Proposed modification to clause 150.5.1 PMD block diagram

IEEE P802.3cm 400 Gb/s over Multimode Fiber Task Force
Vancouver, March 2019

Figure 200-2-Block diagram for 400GBASE-SR4.2 transmit/receive paths

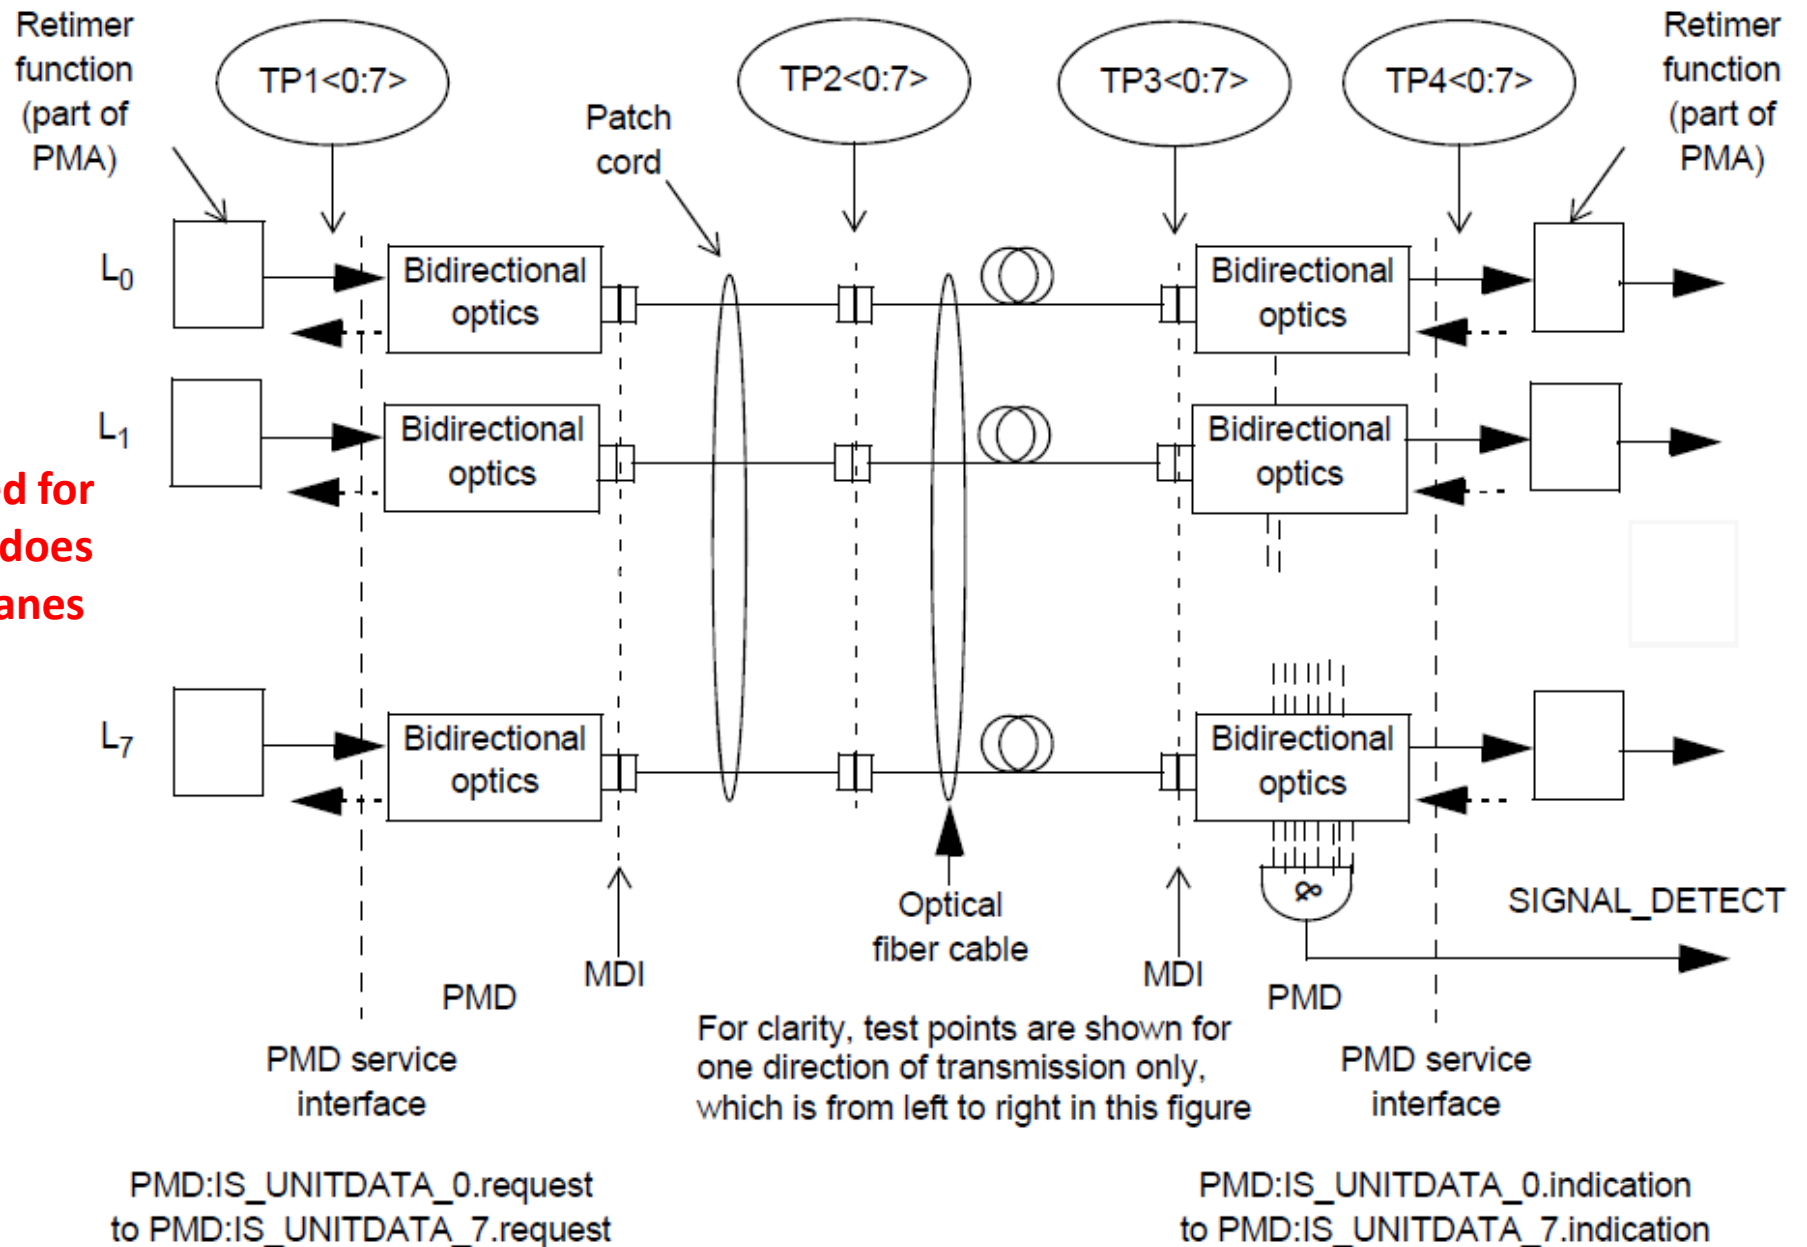
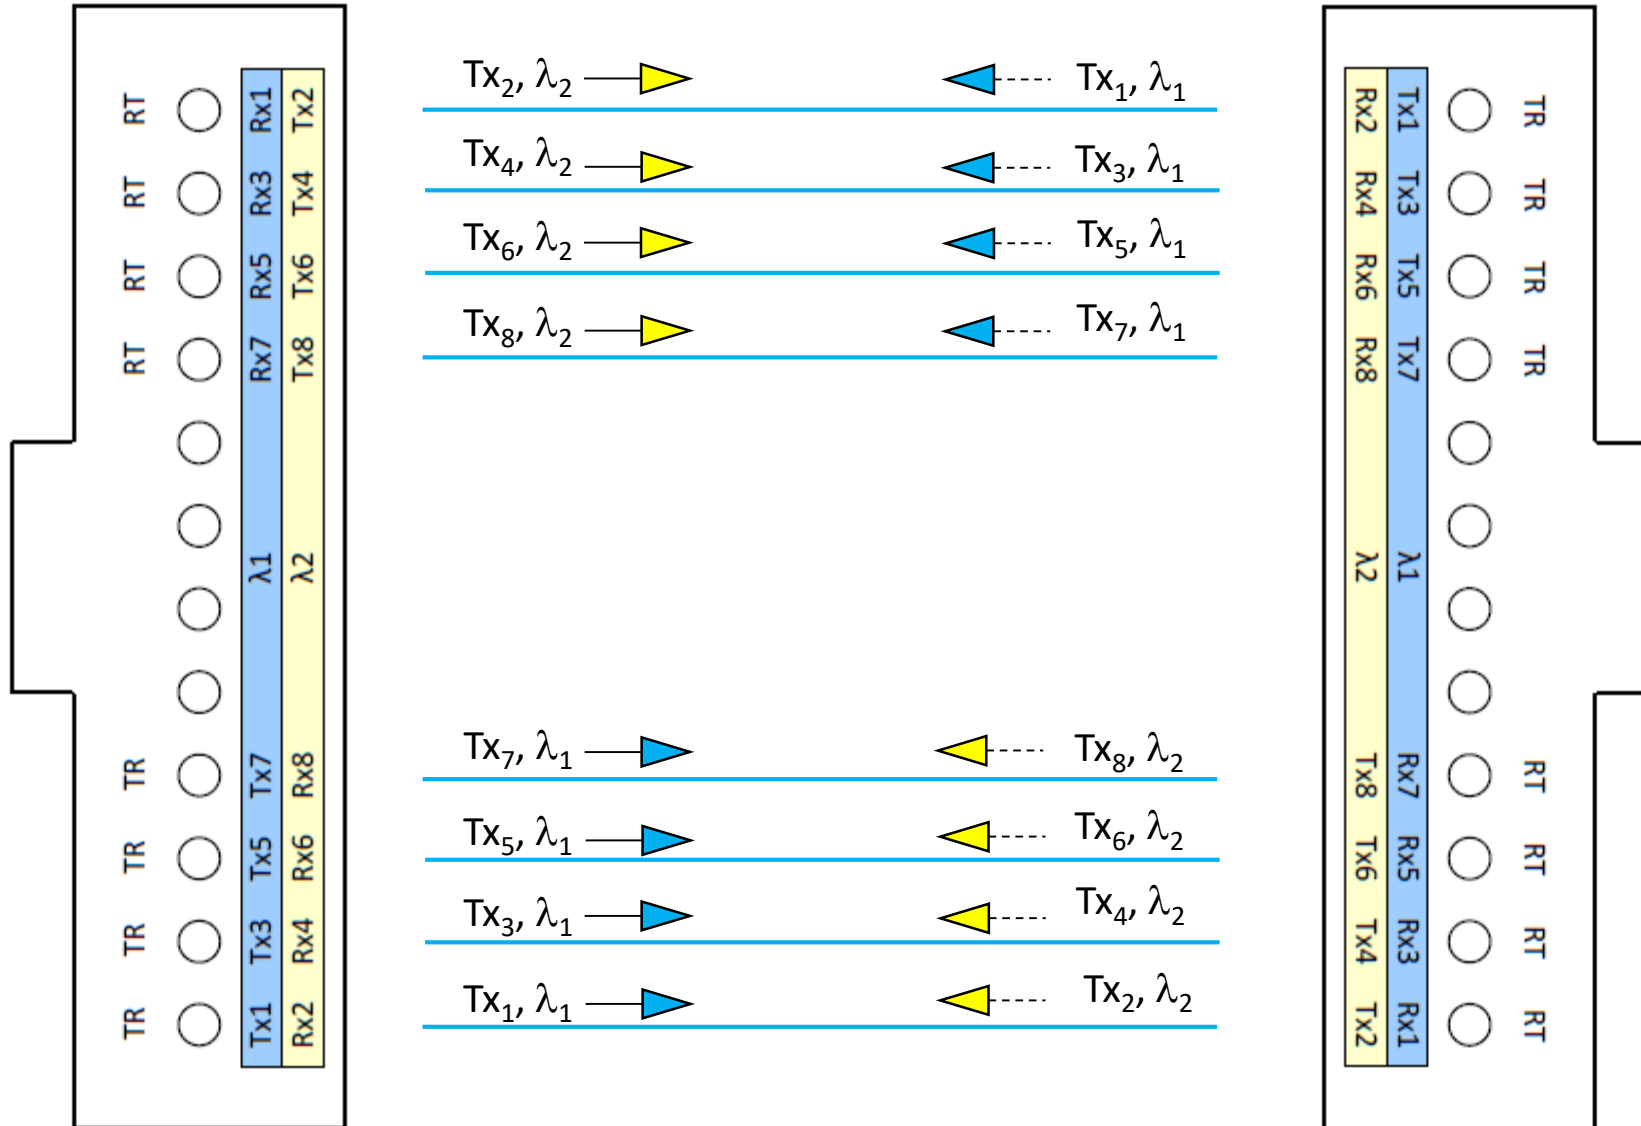
This figure is under specified for bidirectional transmission, does not relate wavelengths to lanes

Proposed Figure
